Staff Report & Recommendations

Bellikka Townhouses

Type II Site Plan Review

(2020-004-SPR) August 27, 2020

Bellika Town houses - Front wall vs Garage % coverage

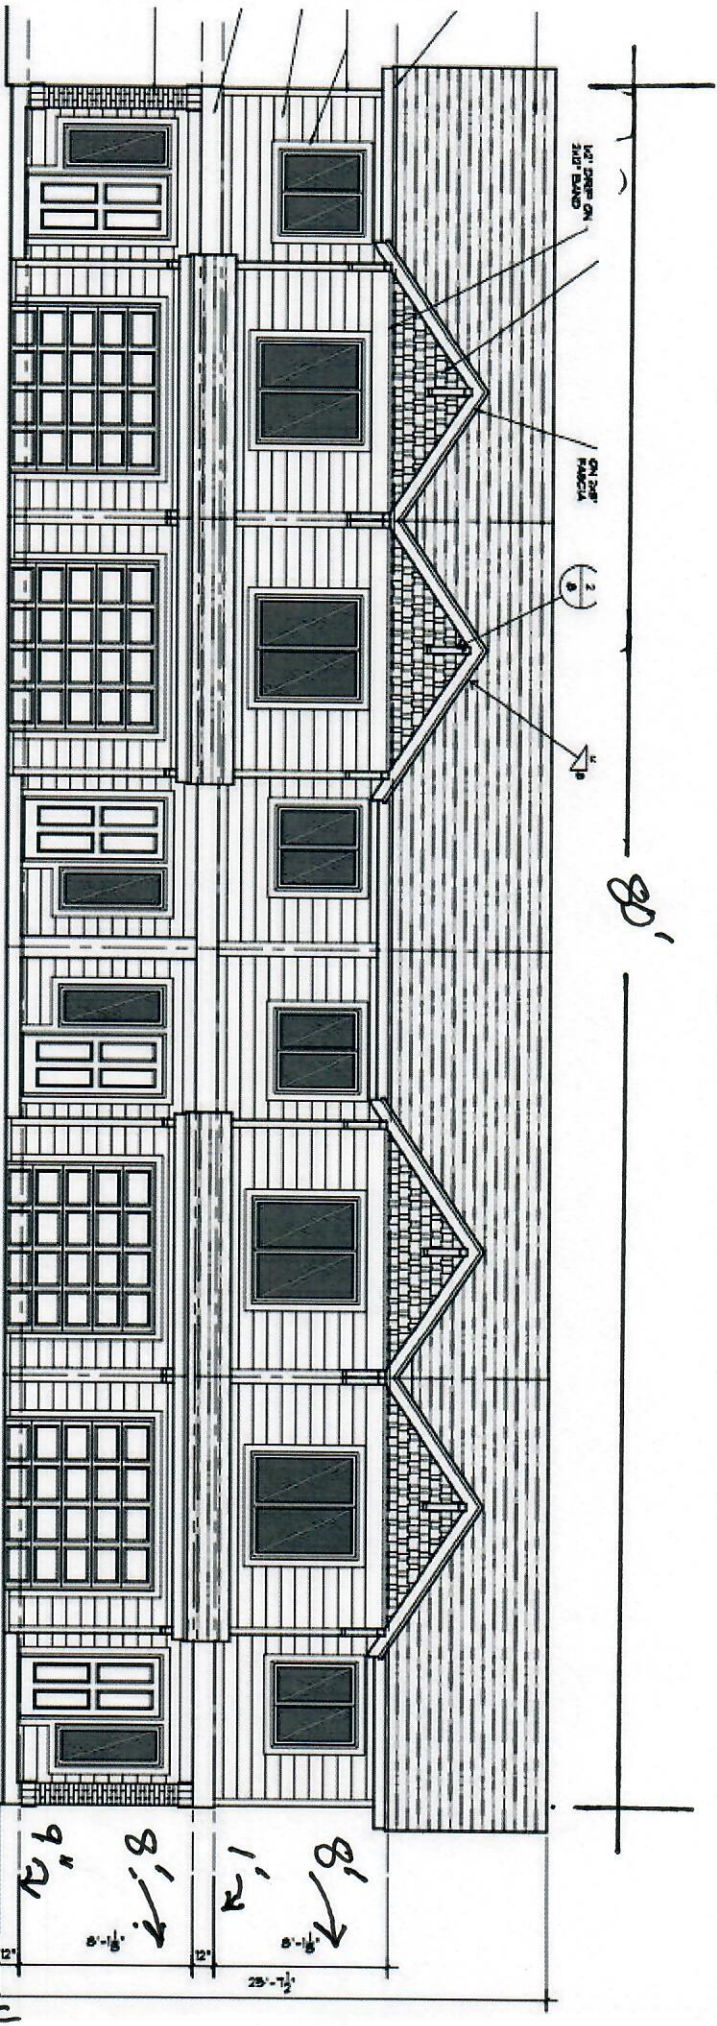
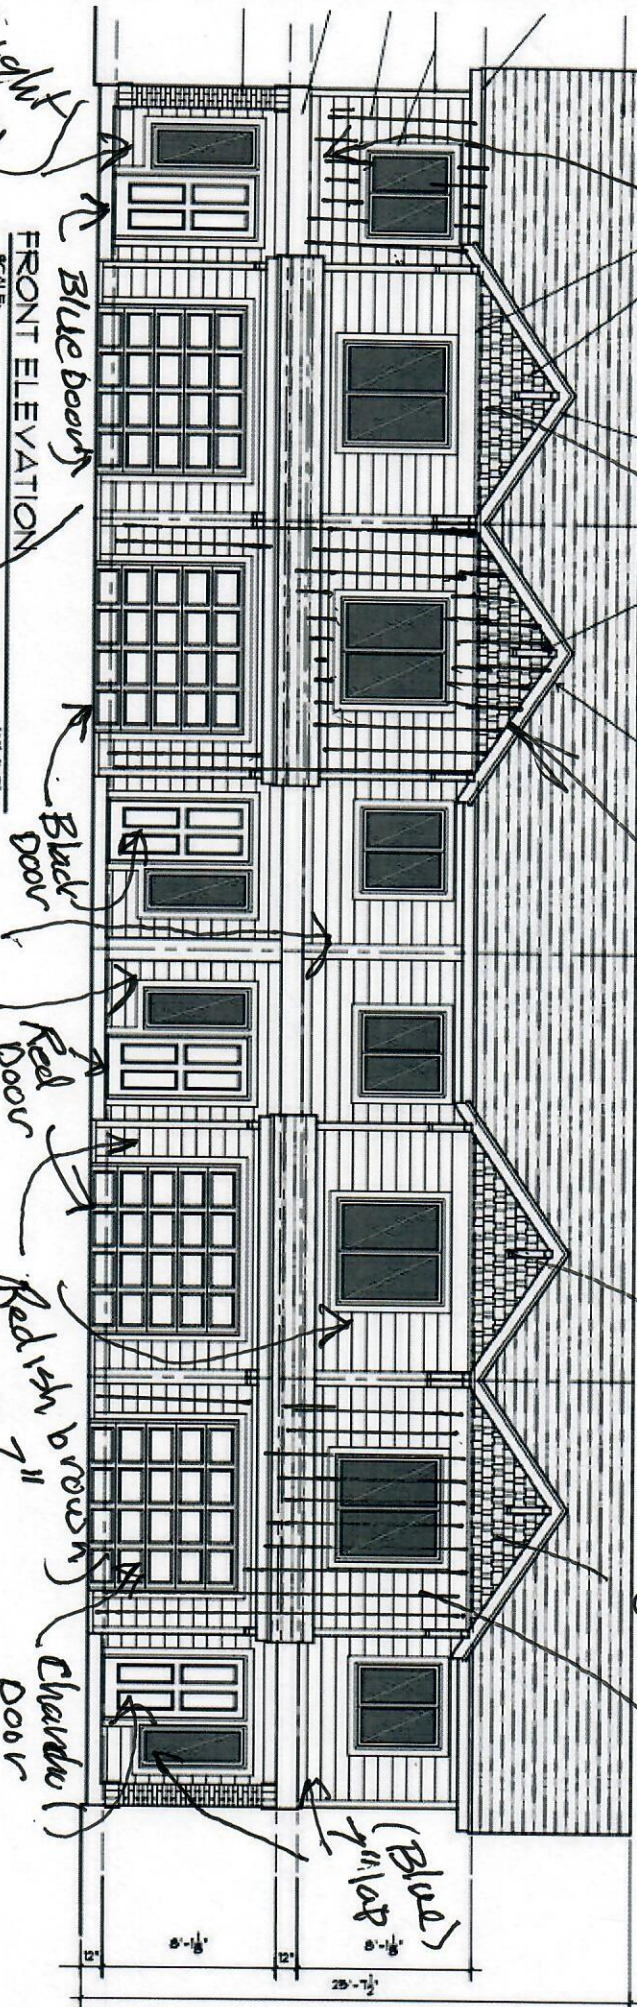
Findings: Each unit has approximately 340 square feet of wall space on the garage wall area facing the public right-of-way. Each face contains 1 5-foot x 5-foot window, one 2-foot x 5-foot sidelight window, one 4-foot x 4-foot window, and one 3-foot by 6-foot and 7 inches door. Considering the garage door is not included in this 25% calculation the total equals 70.75 square feet and is 20.8% coverage. The garage wall area requires an additional 14.25 square feet to meet the 25% requirement. This criterion is not met.

Condition of Approval: Prior to building permit approval, the applicant must provide an additional window/door area to meet the 25 percent requirement in LCMC 18.140.040 (5)(c) on the garage wall area facing the public right-of-way. This could include larger windows and or windows located within the garage door.
